Permit Application Review

Permit No. 2018-108  
Received complete: February 1, 2019

Applicant: Becky Landon; Newport Midwest  
Consultant: Jack Ammerman; Wenck Associates  
Project: The Mariner  
Location: 10400 Bren Road East: Minnetonka  
Rule(s): 4,5,11 and 12  
Reviewer: BCO

Project #	7265-01
Drawn By	JRA
Issue Date	2018-08-01
Issue #	1
Sheet #	<b>EX-4</b>
Sheet Title	FUTURE GRADING CONSTRAINT EXHIBIT

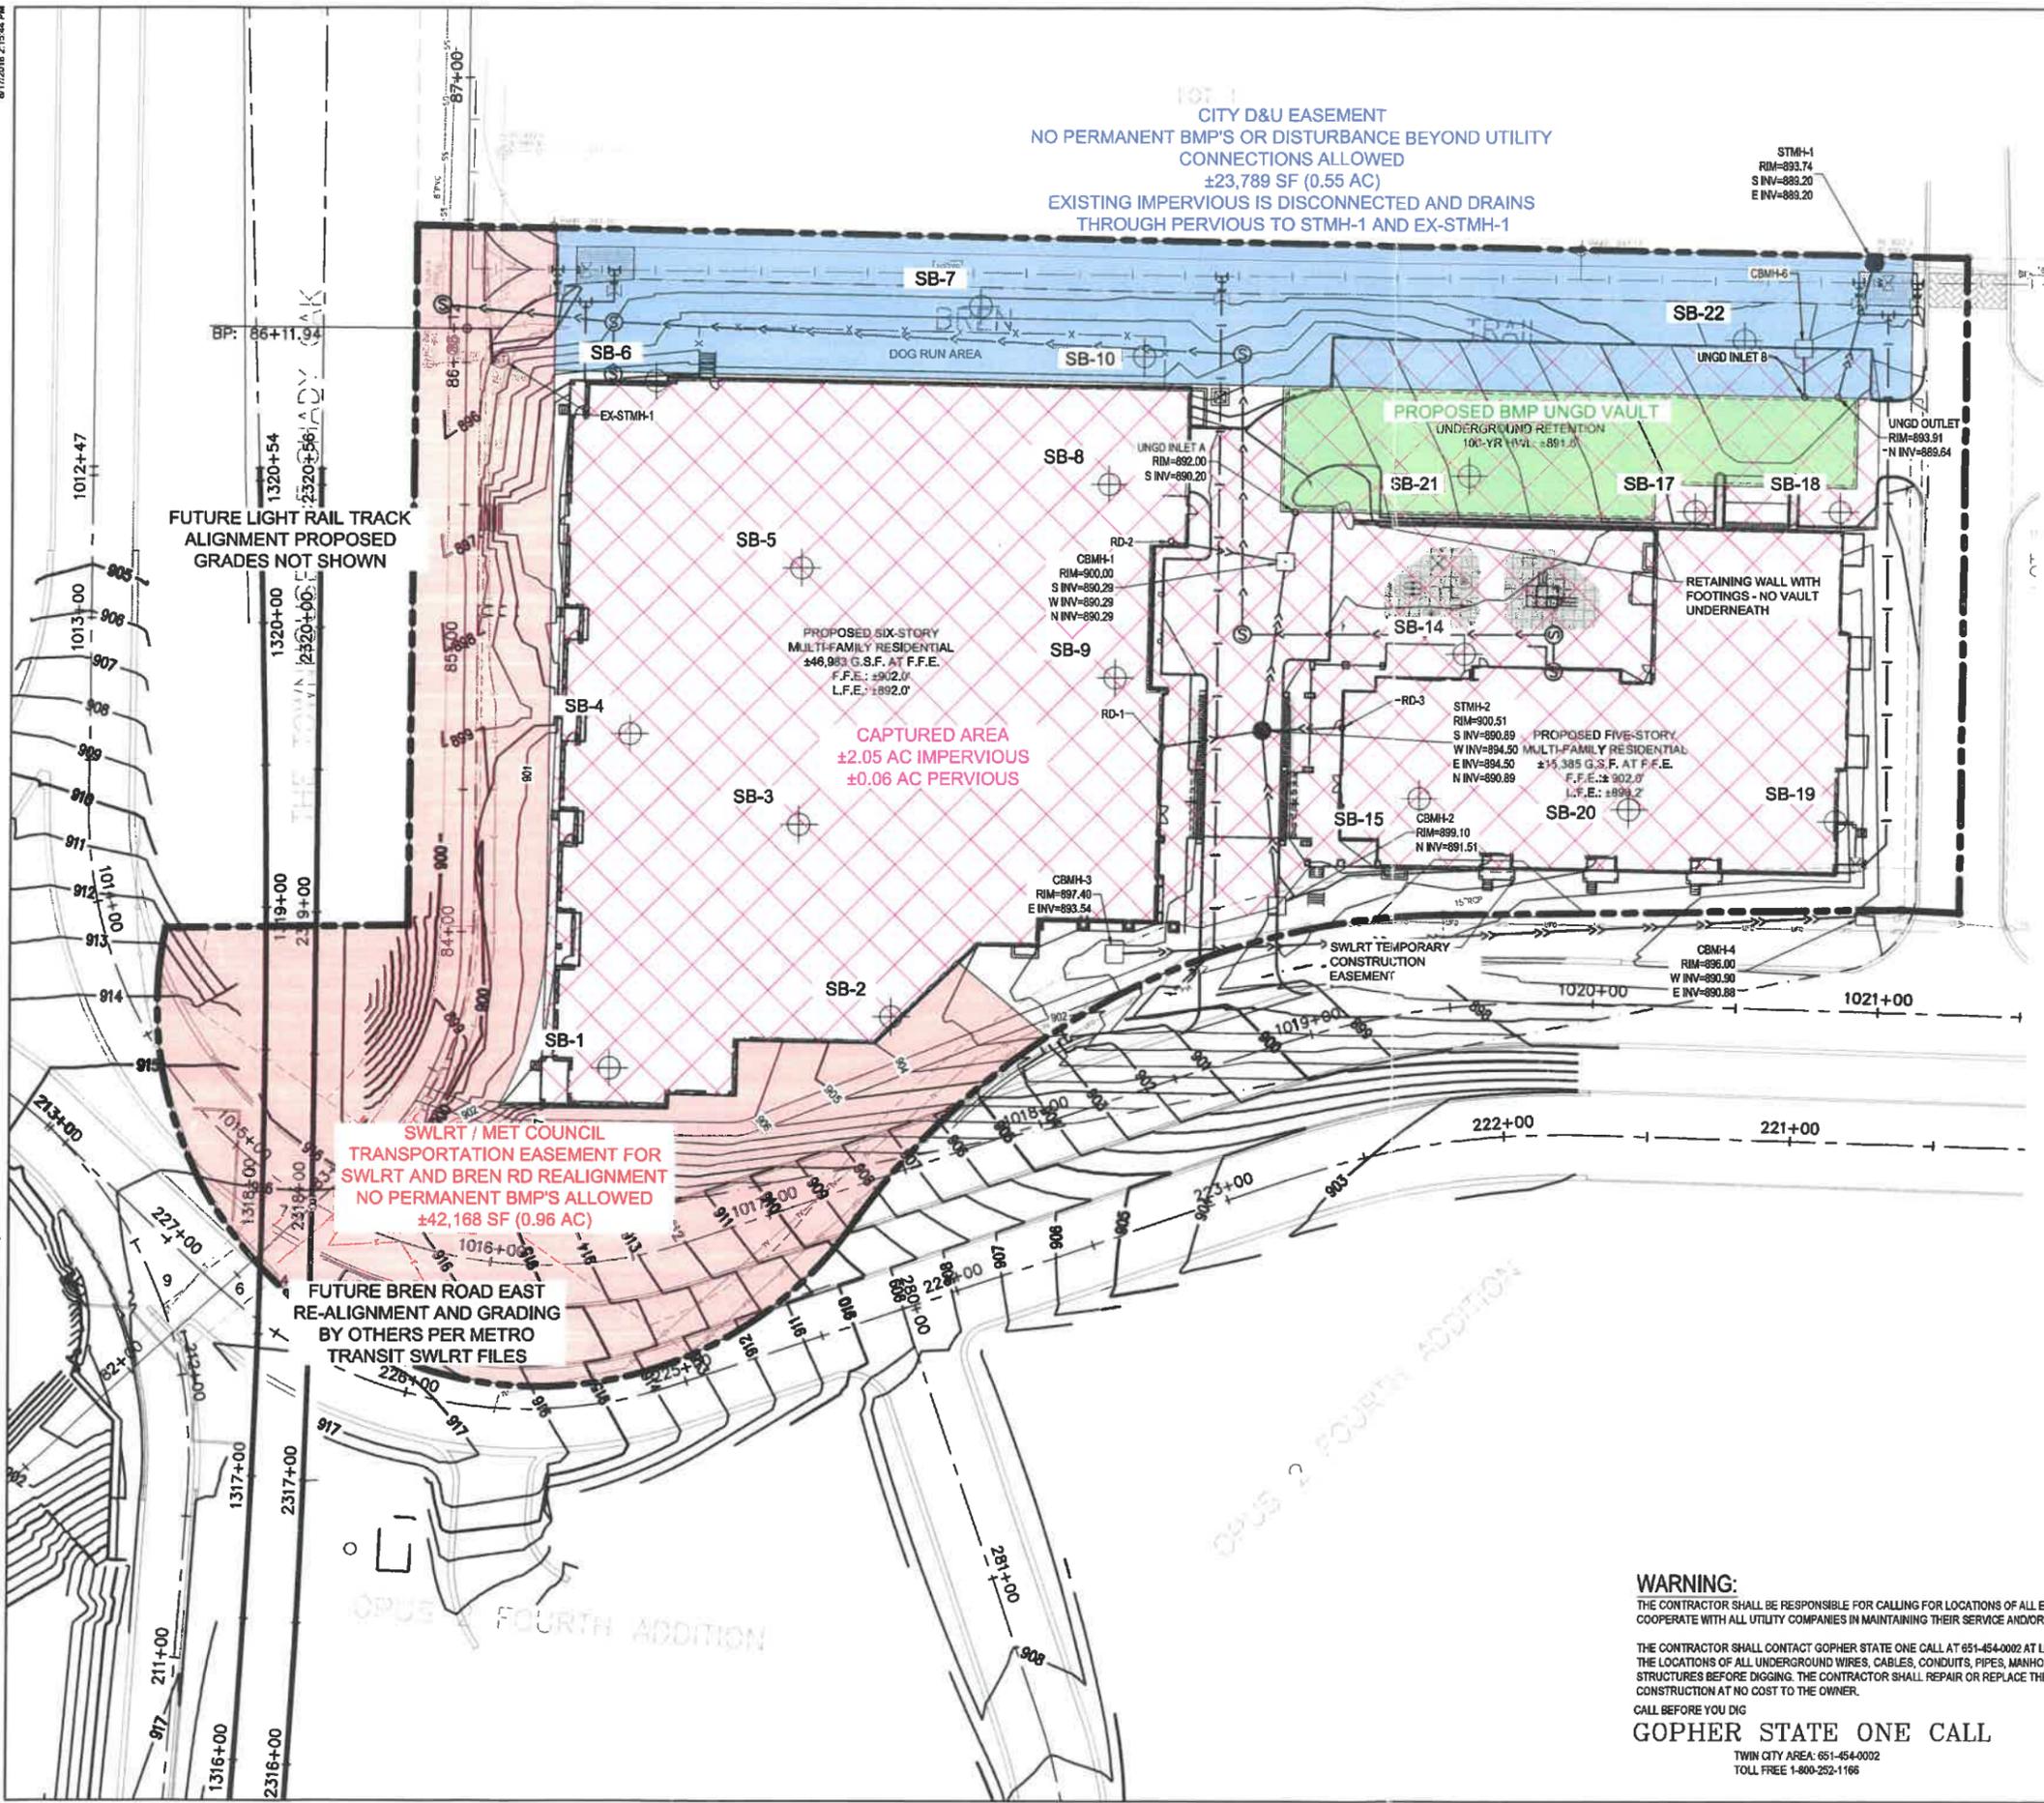
- A 50 foot wide public drainage, utility and trail easement along the north side of the parcels, held by the City of Minnetonka, that is right-of-way under the NMCWD rules. (No land-disturbing activity or other work is proposed or permitted under this application.) The easement is roughly 23,800 square feet in area.
- Bren Road East is being realigned further north as part of the SWLRT project. The road alignment and light rail area is approximately 18,800 square feet in the southwest corner of the property within existing and proposed easements. The SWLRT work is subject to NMCWD permit #2016-88, and the road realignment work (by the City of Minnetonka) is not proposed to be and will not be permitted under 2018-108, if and when issued.

Of the total site, 0.68 acres is within the SWLRT project scope (5,071 square feet of impervious area) and has been removed from the stormwater management requirements. However, a new public sidewalk and driveway construction within the public right-of-way (1.06 acres) has been included in the stormwater calculations for the Mariner project (1,284 square feet of impervious area).
